LINE ITEM #1
I&T: E CONTRACT NO. = NAS9-1100

PRIORITY	DRAWING TITLE	ENGINEERING ORDER DRAWING NO.	EO NO.
C	CAP D/S UPPER OUTRGR PRESS. VENT. SUPT	LDW280-18198	A1

J ROGERS | J STRAKOSCH x1153
ISSUED BY P. WOSSLITZ SECTION V.D.1. GROUP NO. 335 PL 35
CODE IDENT NO. 26512
GRUMMAN AIRCRAFT ENGINEERING CORP
BETHPAGE, L. I., N. Y.
ENG 32.3 REV 3-65

LDW280-18051

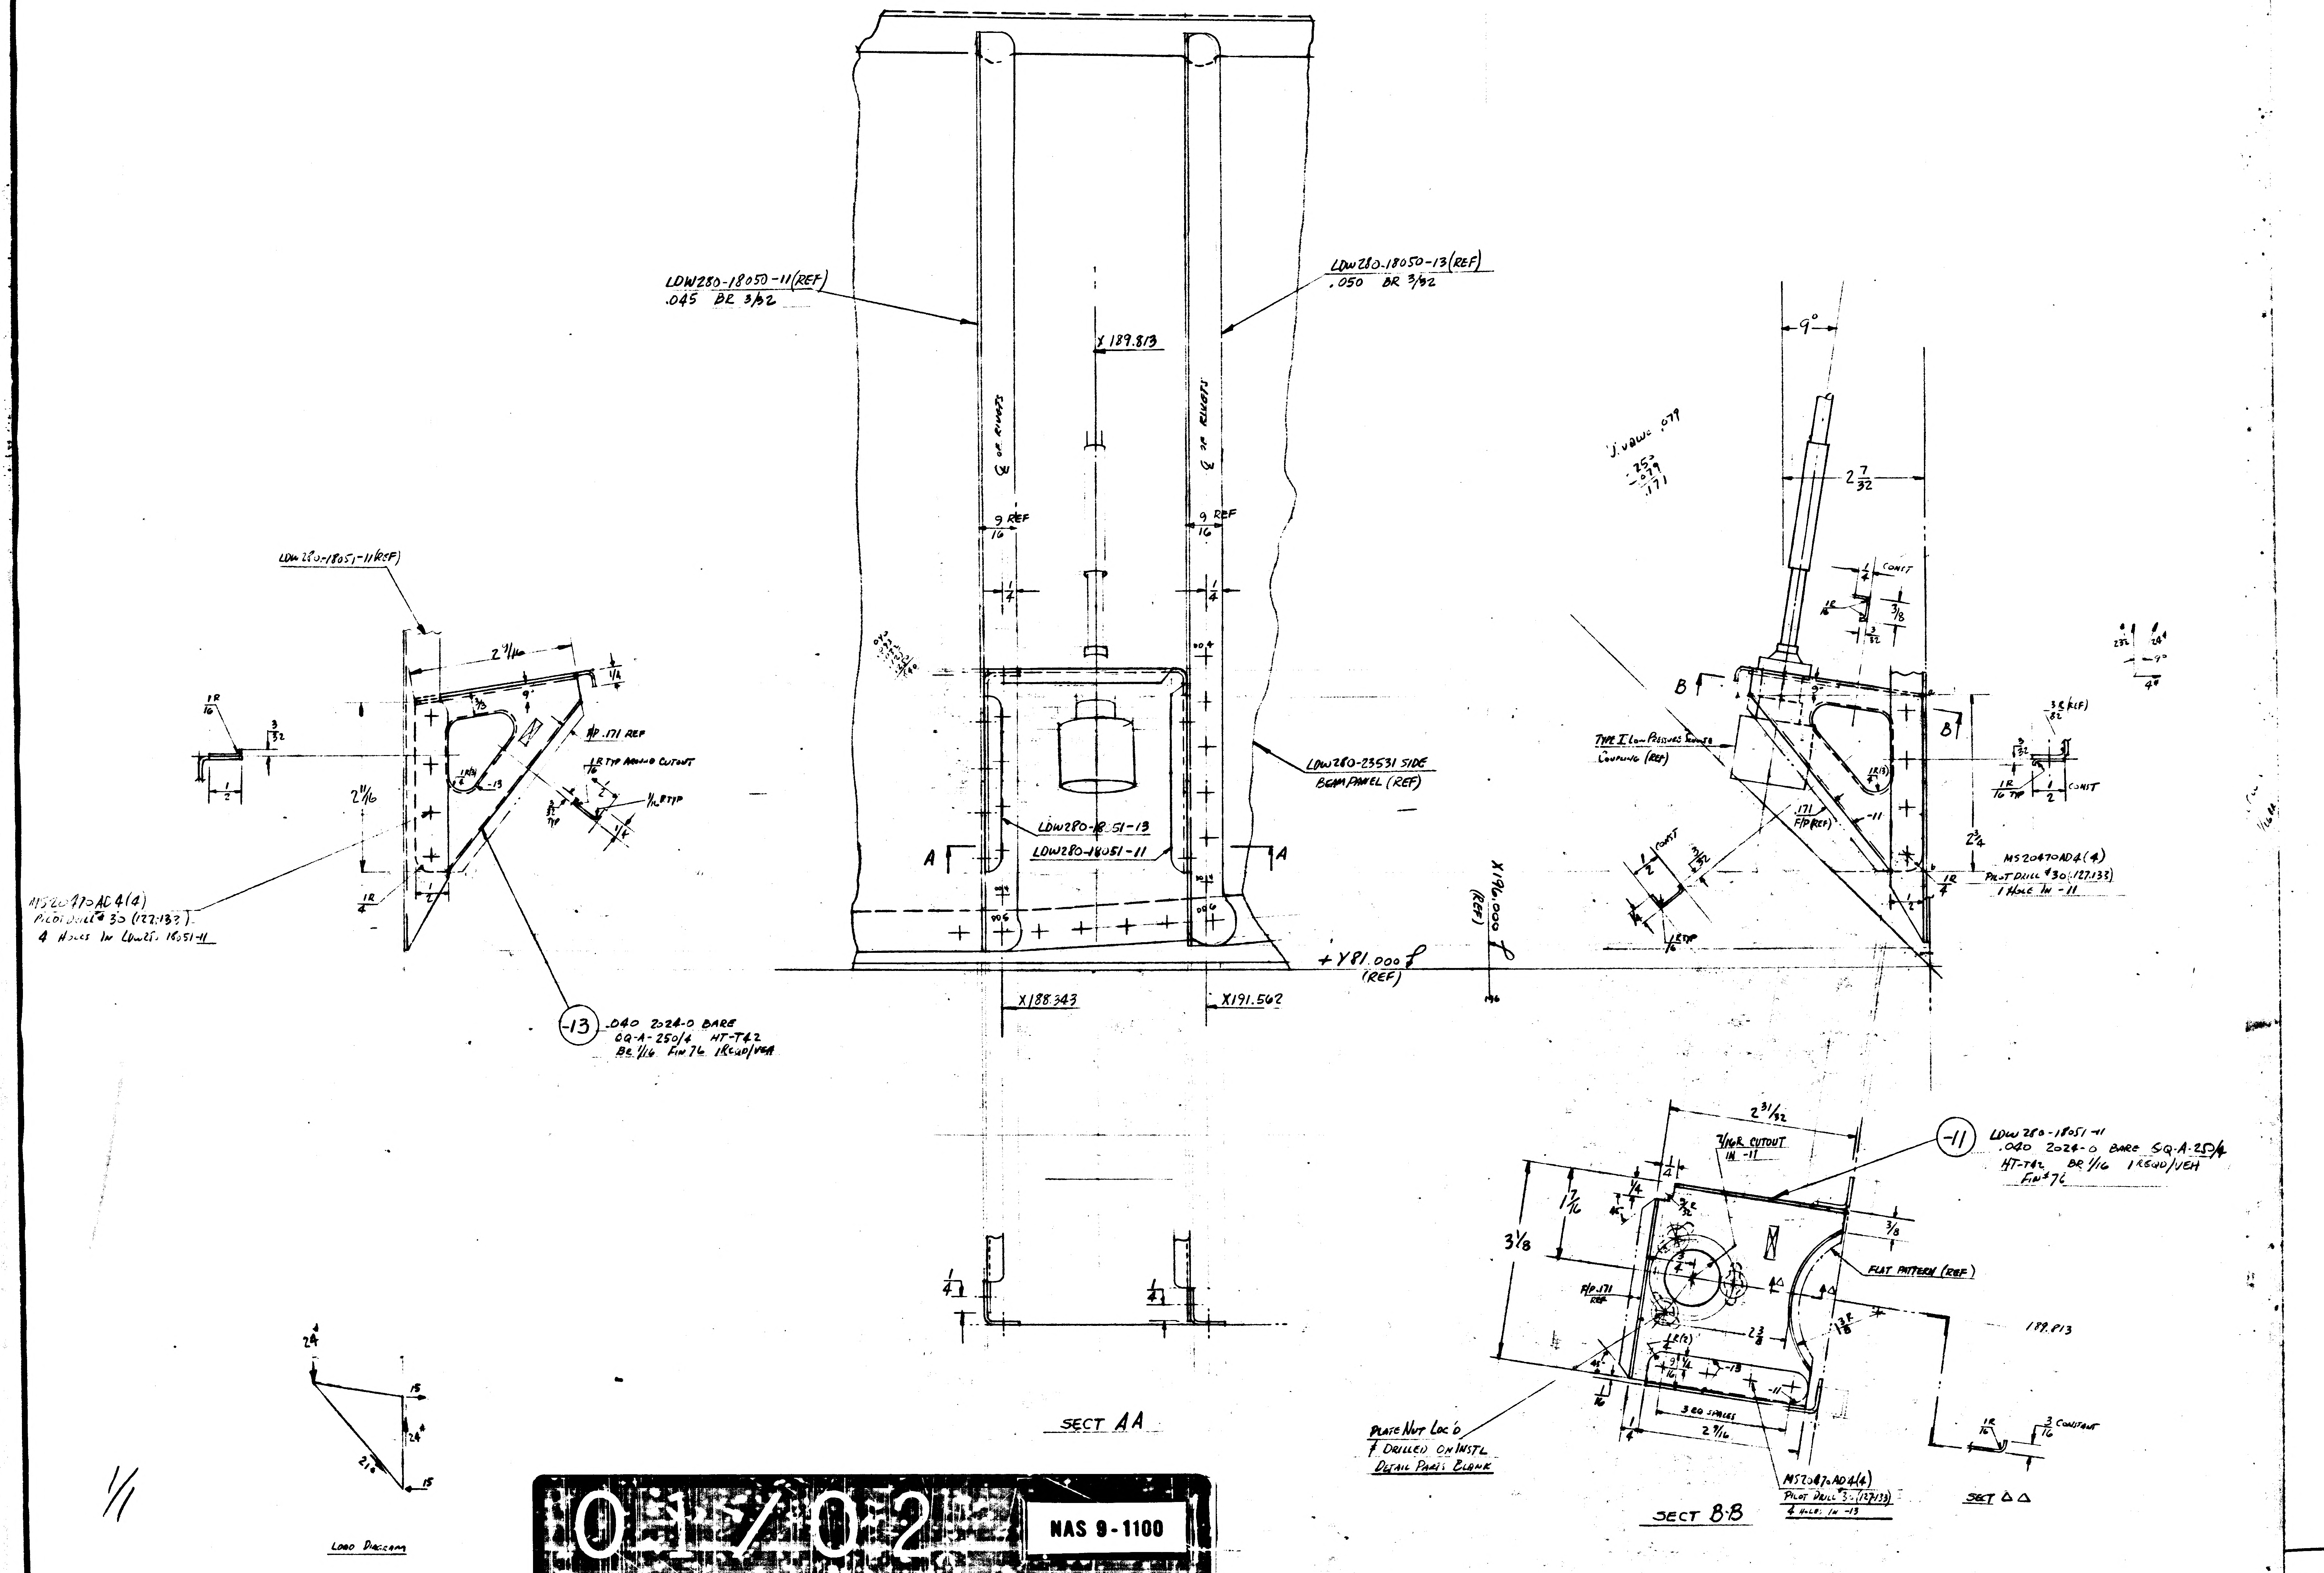
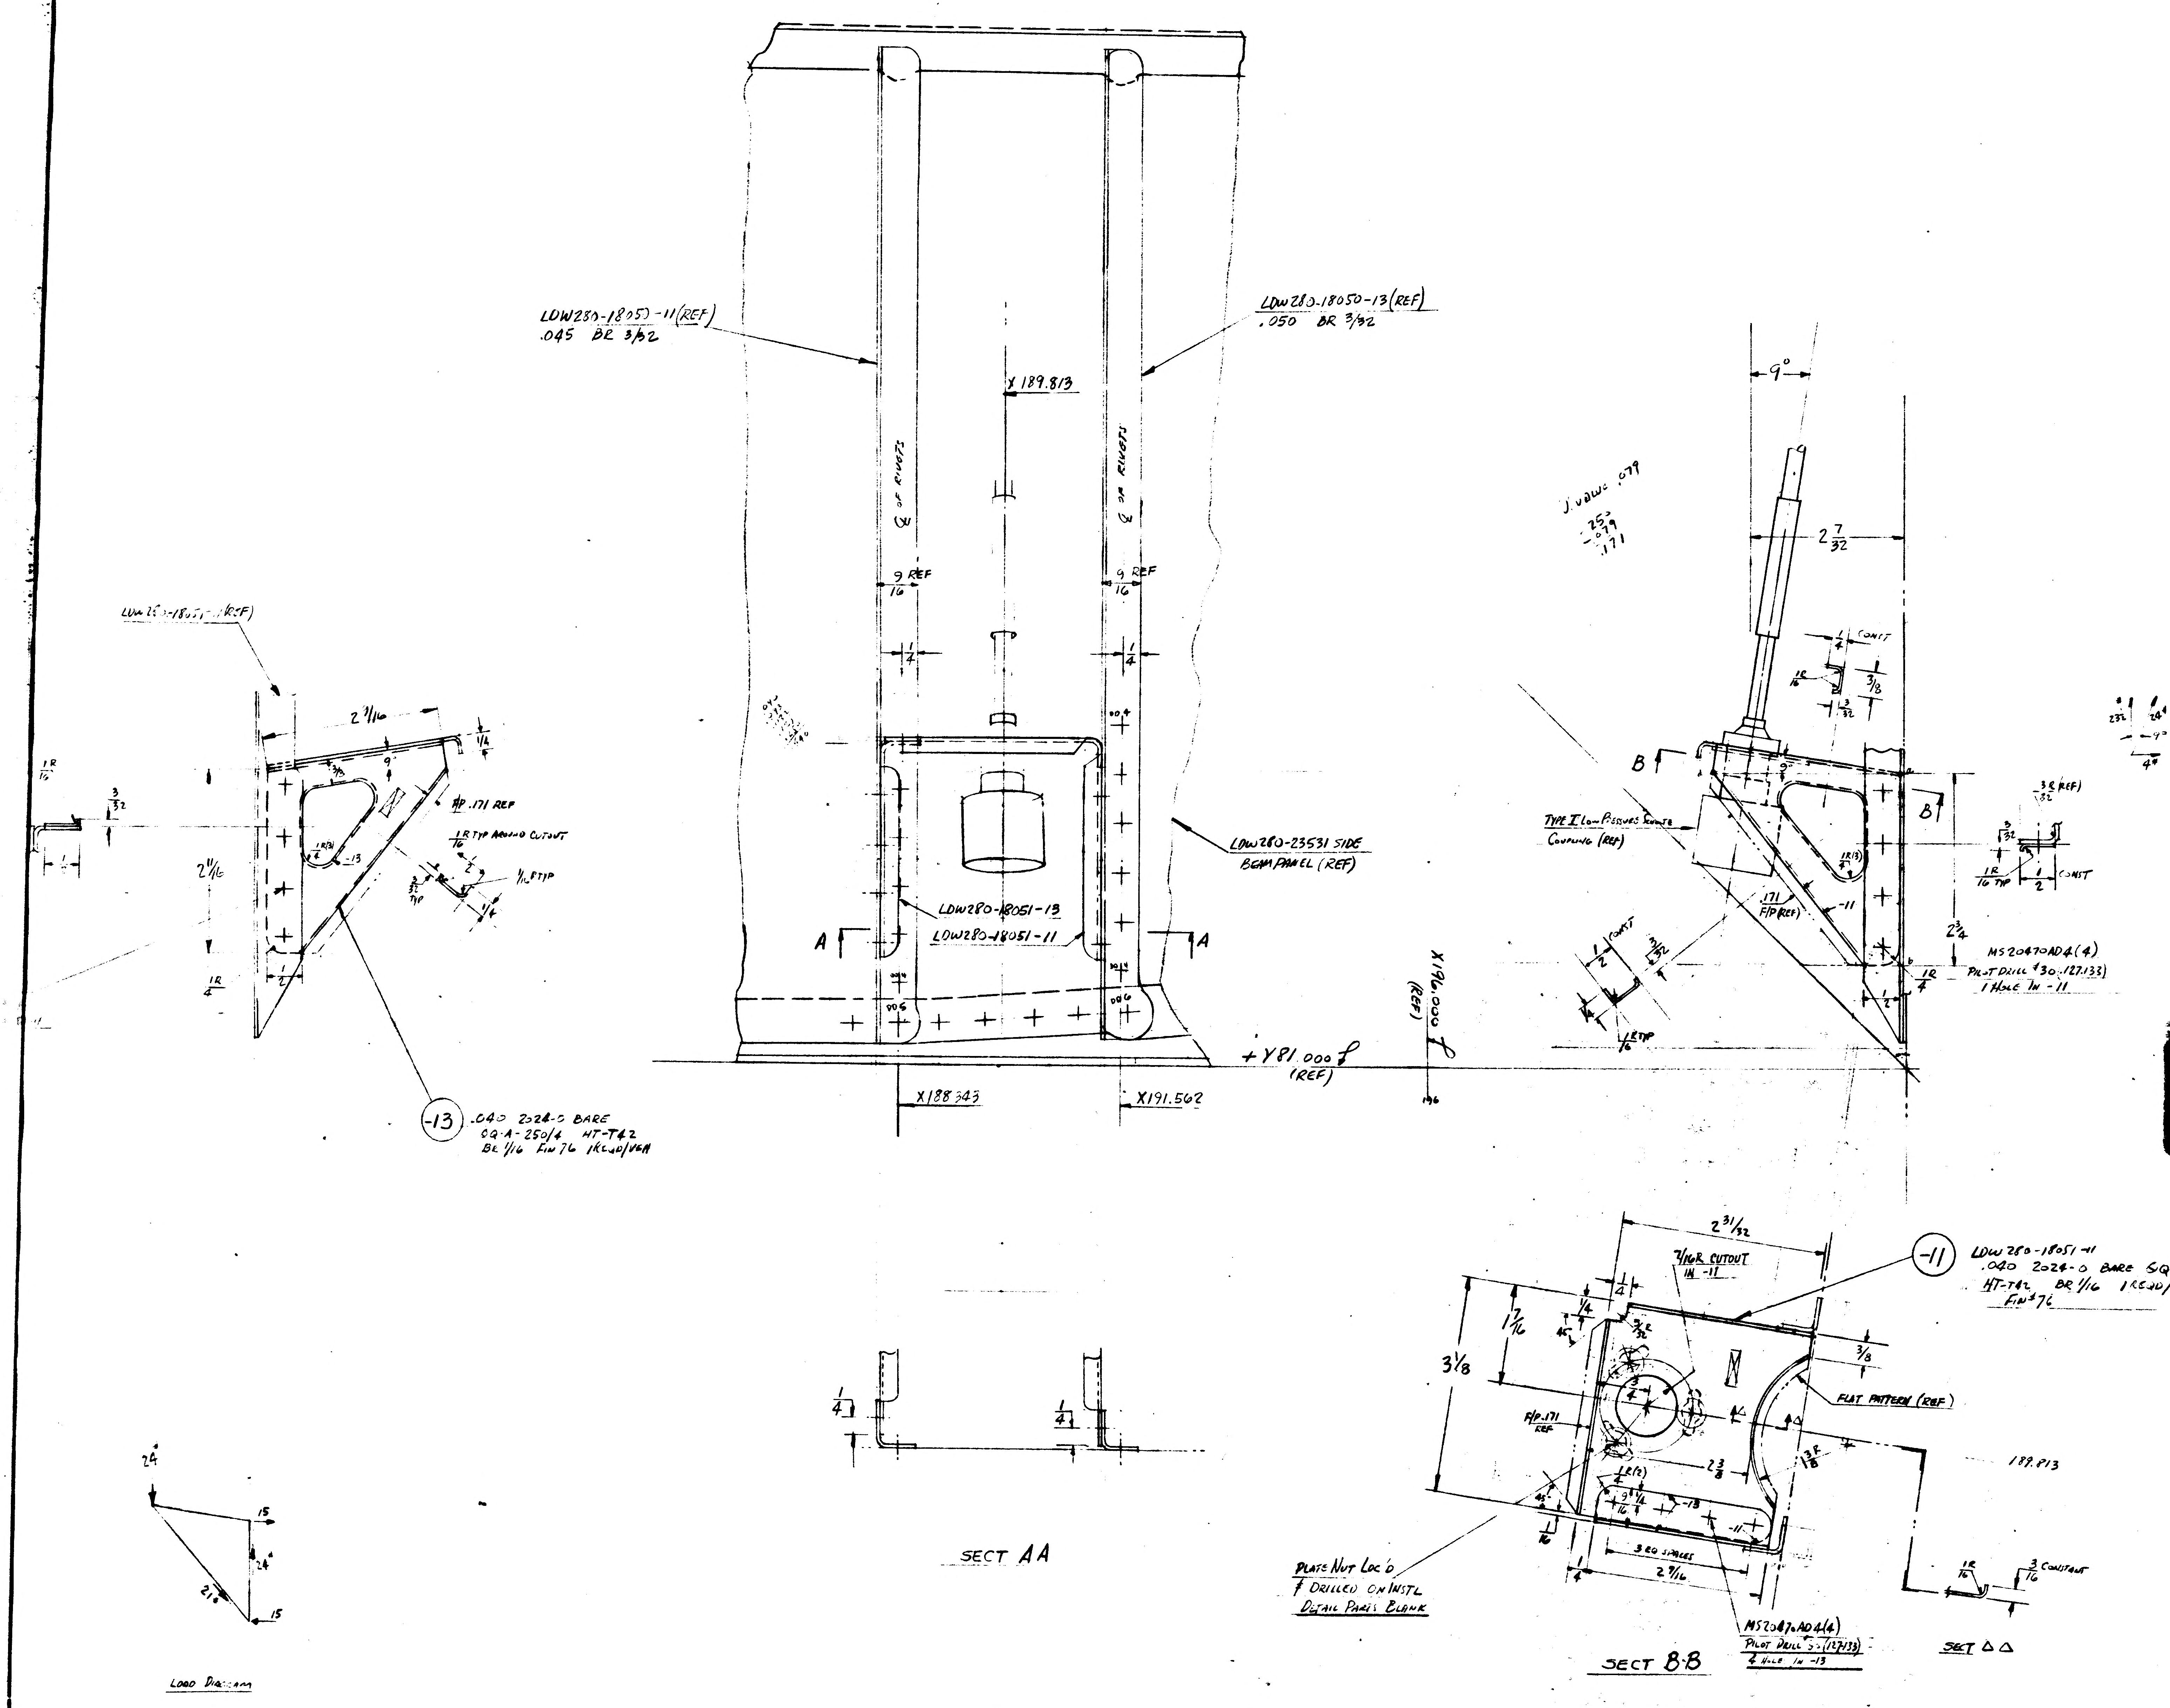
CHANGE LTR	ITEM NO.	SHEET NO.	ZONE	GRUMMAN INFO ONLY	DET SPEC	CLASS I	CLASS II	ENGRG ORDER	DESCRIPTION	EFFECTIVITY	DISPOSITION OF EXISTING PARTS		CHANGED BY AND DATE	ENGRG APPD	GOVT APPD
											REWORK	SCRAP			
									RETRACED NO CHANGE LAST REVISION NO CHANGE. LOFTED DWG (WAS) DIMENSIONED DWG. ADDED SHEET 1.10 P. CARSTENSEN 5-15-67						
A	1	1.00 & 1.10						LEO280-328	FOR -11 & -13 ADDED LM-7 THRU LM-15 EFFECTIVITY	LM-7 THRU LM-15	NOT	REQ'D	CARSTENSEN 5-15-67	☒	☒
	2	3.00						EOA2	FOR-11 ADDED 3/8 R, 9/32 R(2), 7/32, 30°, 13/16 & 25/32 DIMENSIONS	LM-2 THRU LM-15	✓
